## BUILDING ENVELOPE COMMISSIONING REPORT

Project Name Winooski School - Building Envelope Commissioning

Project Number 21-20-162
Date of Visit January 4, 2022

Purpose First Instance Tests - ASTM E 1186 (Fog Testing)

Curtain wall tested

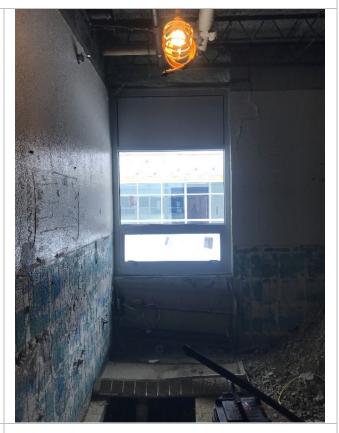
**Results:** We tested a new curtain wall placed into existing construction and found a small leak through a void in the caulking. Overall the curtain wall performed well. BVH spoke with SAG prior to leaving the job and they will address the void by using additional caulk.

Small void in caulking at corner of operable window
